Arlington High School Building Committee

Meeting Materials Package – 5/3/2022

Change Order (CO)

Items included in this Change Order:	Cost:
CR 093.1 RFI 216.2 Provide Fire-rated ceiling at Stair 1 for elec conduit.	\$ 4,348.03
CR 189R1 ASI-112-112.1 Misc steel and conc changes Bldg B.	\$ 8,833.05
CR 203R2 ASI-121 Chase wall revisions abutting locker pods Bldg B.	\$ 35,810.78
CR 222 ASI-137-137.1RCP Revs- added GWB soffit at Part E.	\$ 2,045.99
CR 266 CCD-031-ASI-163 provide Spandrel glass in lieu of clear at CW52.	\$ 4,337.64
CR 291 ASI-176 Plywd barrier at catwalk gap between perimeter wall.	\$ 7,408.41
CR 292 ASI-180 Provide milwrk cover of steel box-beam at Aud. Balcony.	\$ 4,903.99
CR 302 Provide steel angle for CW doors/sidelights support at foundation.	\$ 6,435.28
CR 306 Rev to ceiling at Guidance area- added ceiling trim-soffit condition	\$ 3,752.54
CR 320 RFI-392 Rev GWB condition at CW49 for modified CW to wall relationship.	\$ 3,613.26
CR 323.1 RFI-582 Provide Boiler EPO Switches PH 2 areas.	\$ 3,712.59

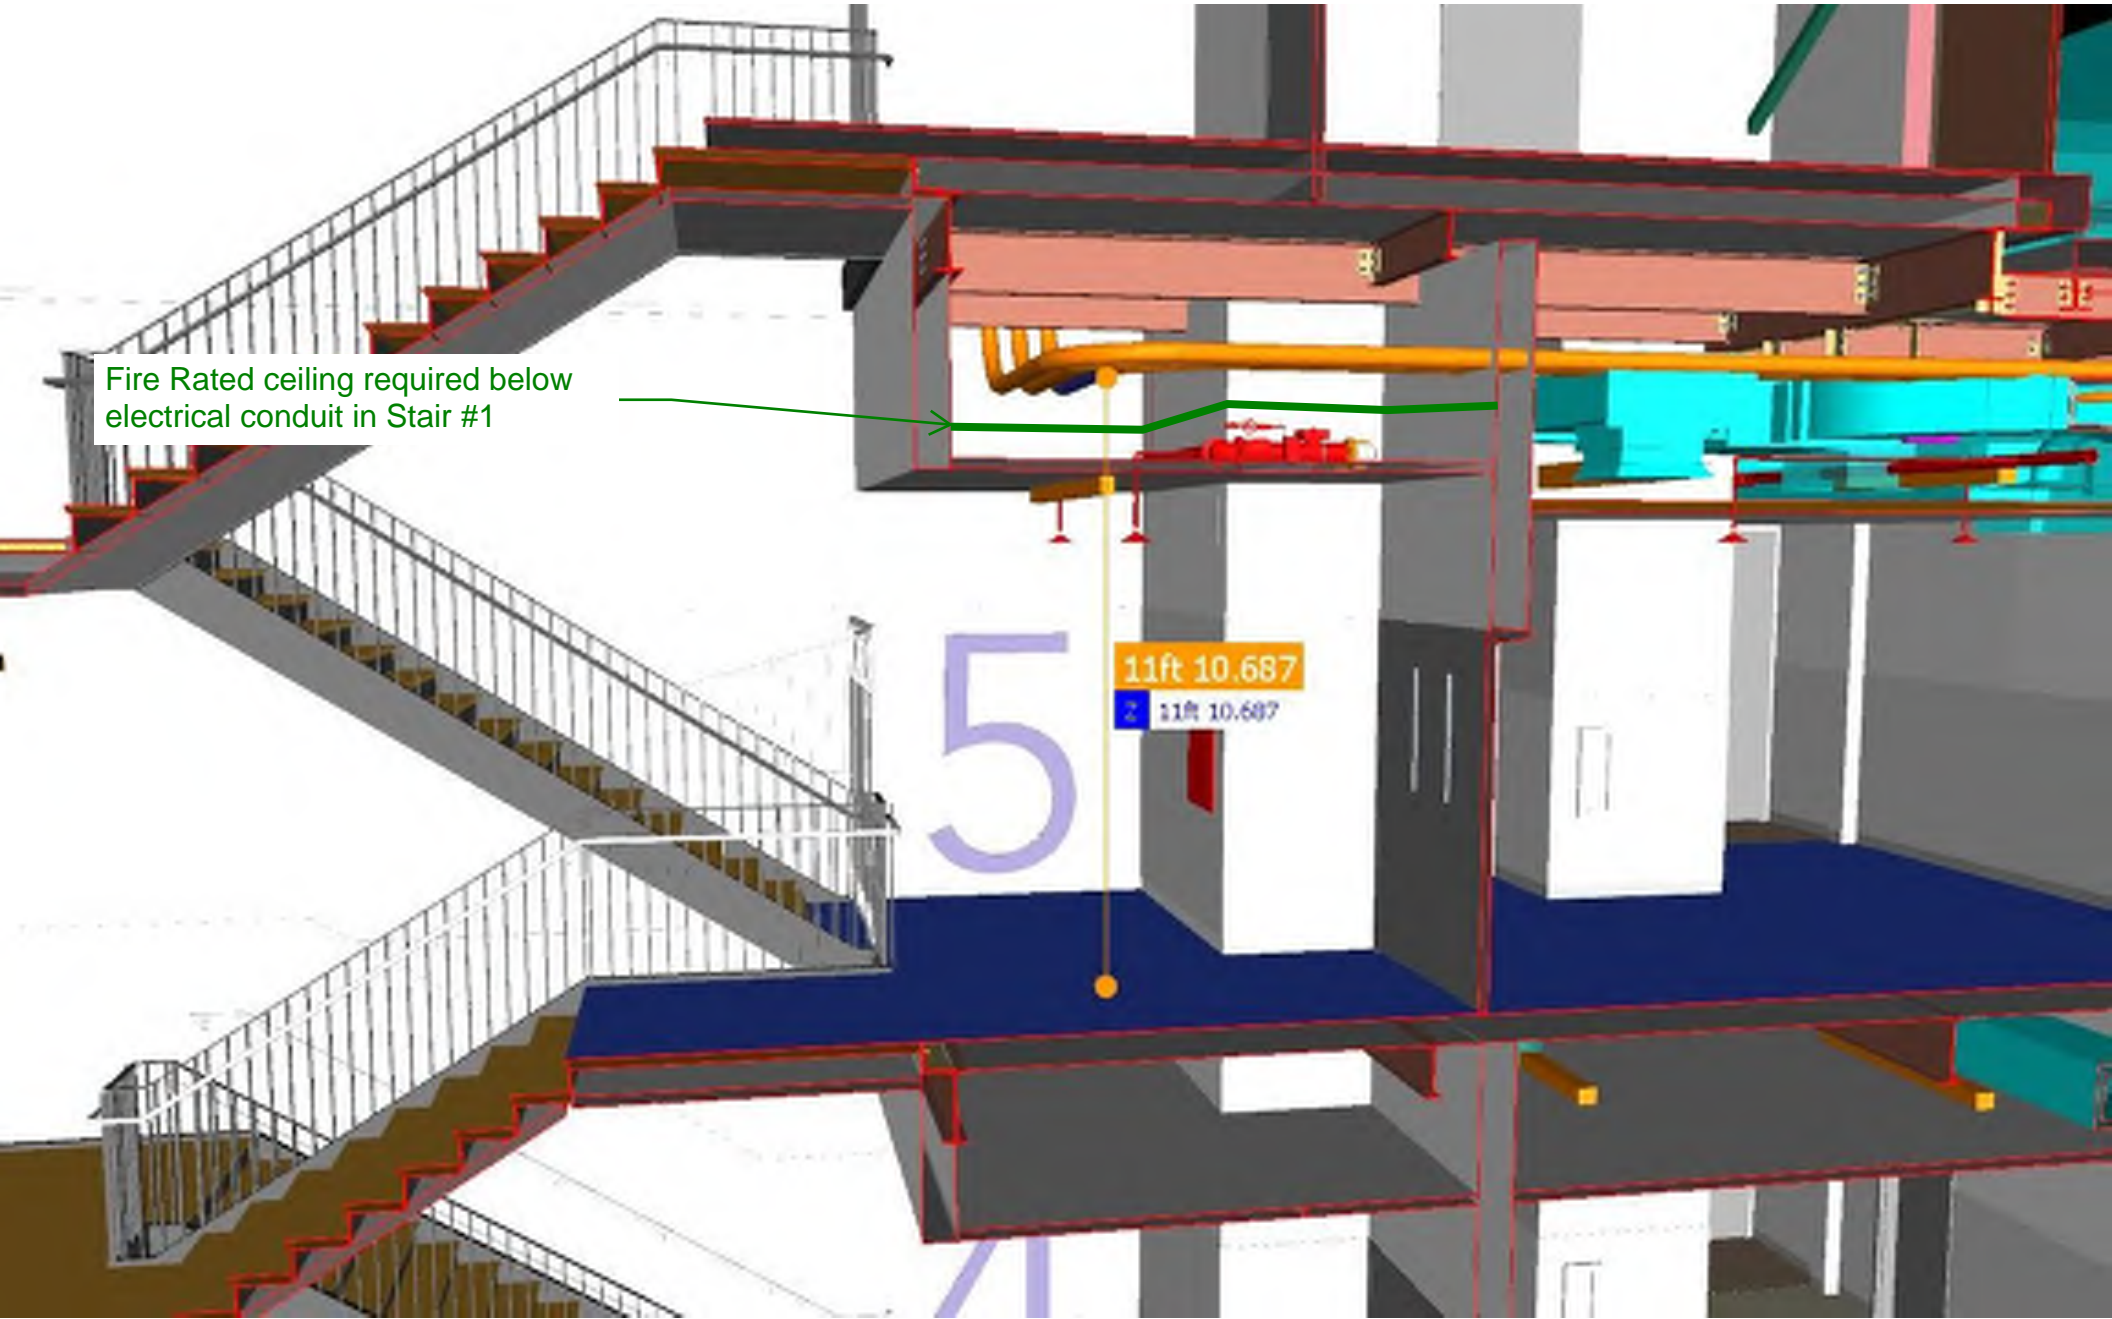
Question: Should the drop ceiling reflected in Stair 1 on level 5 have a rated ceiling to
allow electrical conduit system to pass through and access the Standby Electric Room on
the roof?

In lieu of installing a 2-HR rated ceiling assembly, provide pricing for installing a 2-HR thermal blanket wrap of the conduit group. See attached product data and approximate materials listing (confirm total length/width of conduit run within Stair). *If this pricing is less than the anticipated pricing of a Gypsumboard assembly (Phase 1 Stair 2 pricing can be used as assumed cost for GWB ceiling assembly in this Stair 1) this approach can be pursued. If this approach is more cost, then a GWB ceiling can be provided.*

SCALE: 1/8" = 1'-0" DATE: 05/20/21 DRAWN: MI CHECKED: AD

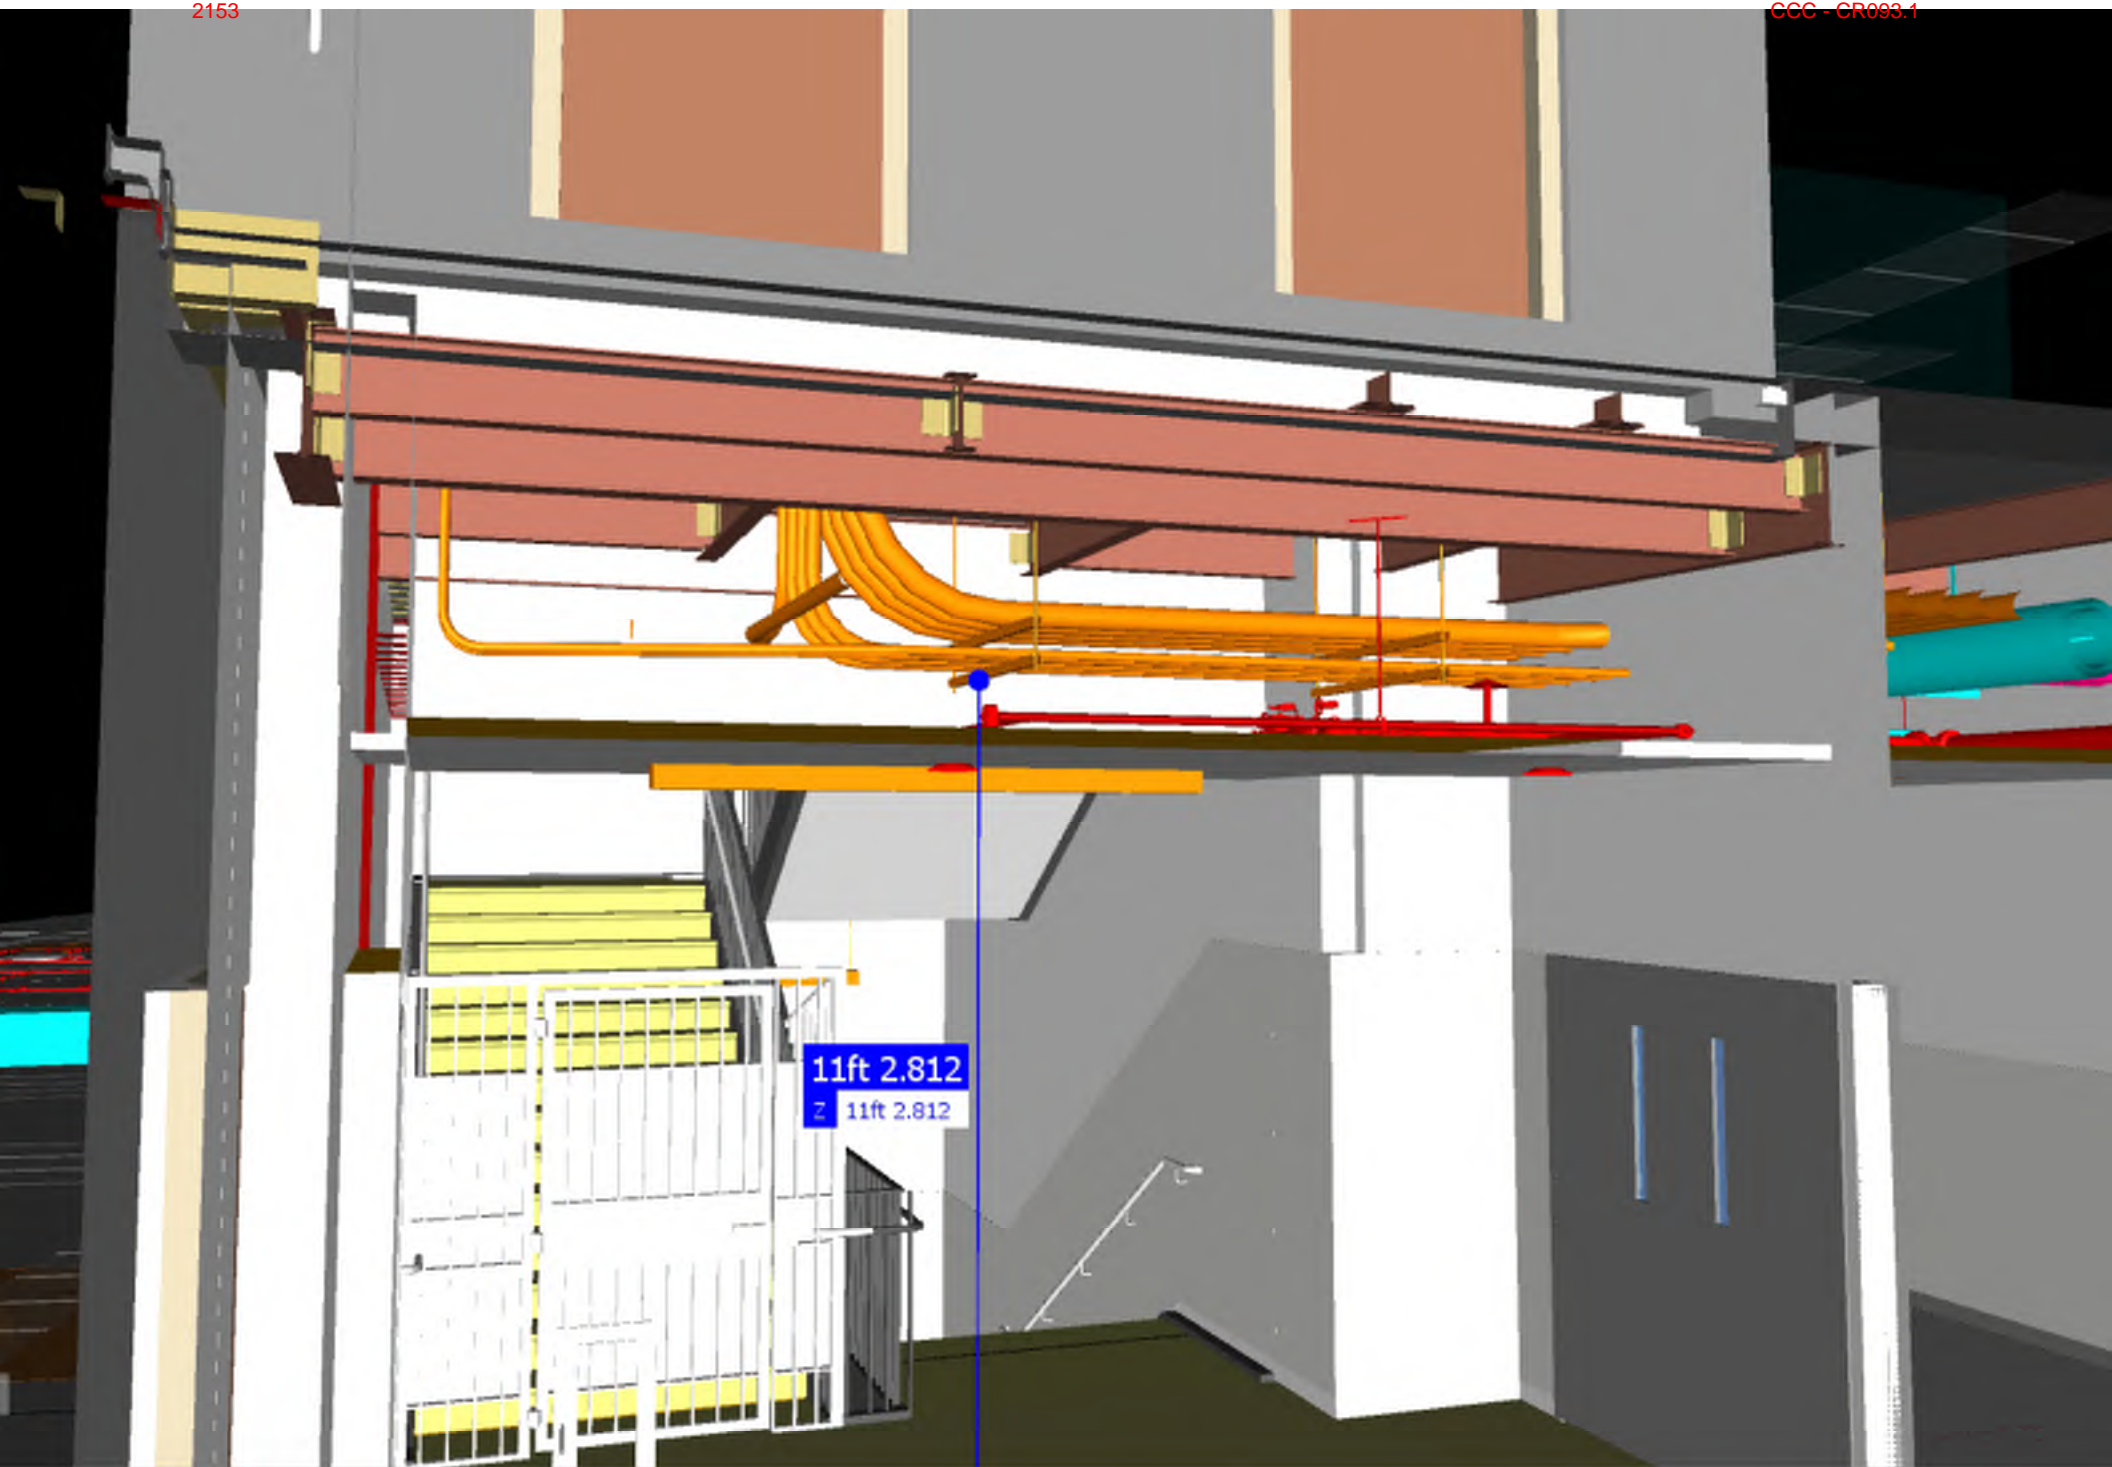
After reviewing the response to RFI #216, the electrical coordinator adjusted the conduit in Level 5 Building D Stair 2 as tight to steel as possible. They were able to adjust the bottom of the conduit to 11'3". In order to accommodate the frame/sheetrock, the ceiling will have to be reduced down to 11'. Please provide ceiling detail as indicated in the RFI response.

Horizontal shaftwall ceiling assembly with height indicated in attached sketch SKA-074. (understood that this will be added cost).

A2.7c - Second Floor Slab Edge Plan

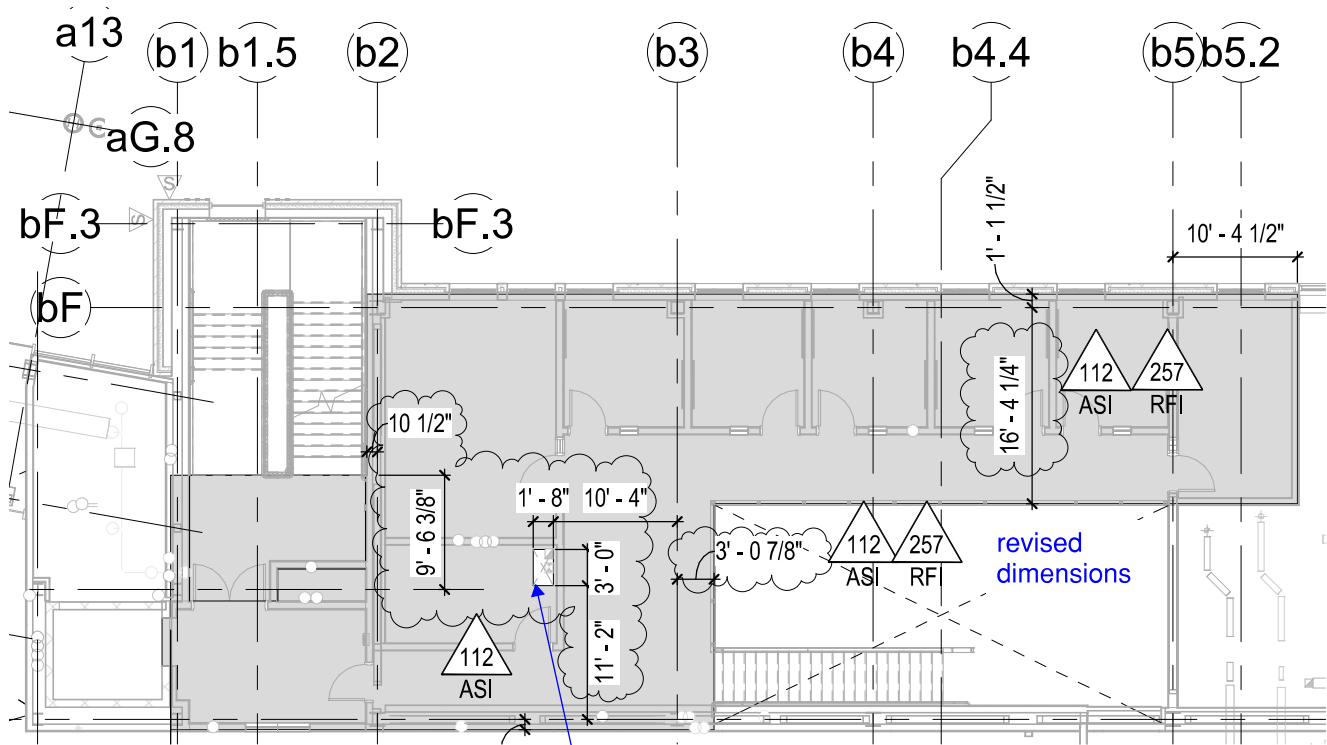
Deleted slab
opening

Revisions to A2.7b Upper First Floor Slab Edge Plan
and A2.7c Second Floor Slab Edge Plan.

SECOND FLOOR FRAMING PLAN - PART B
1/8" = 1'-0"

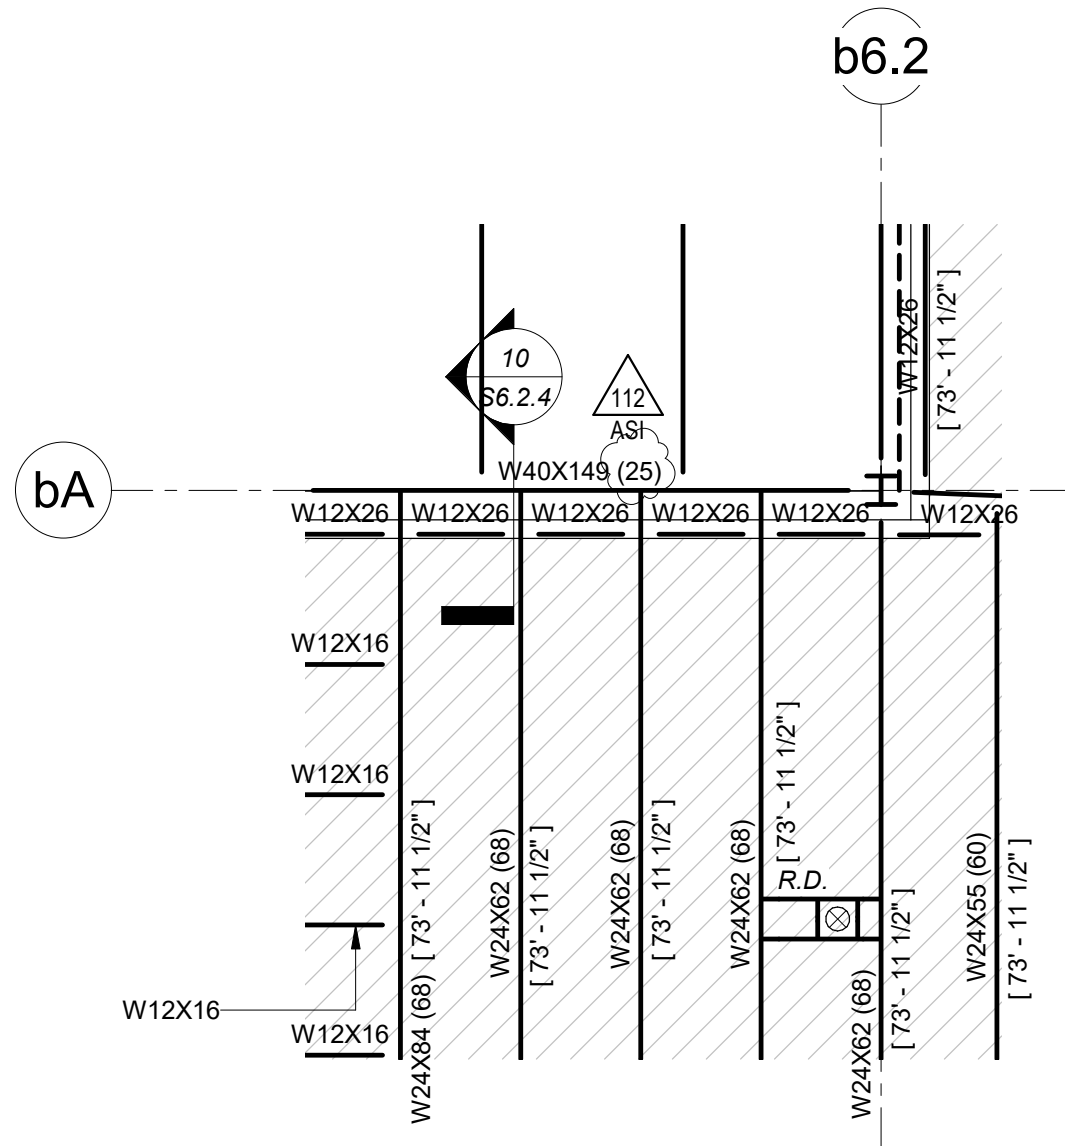
shear stud information provided
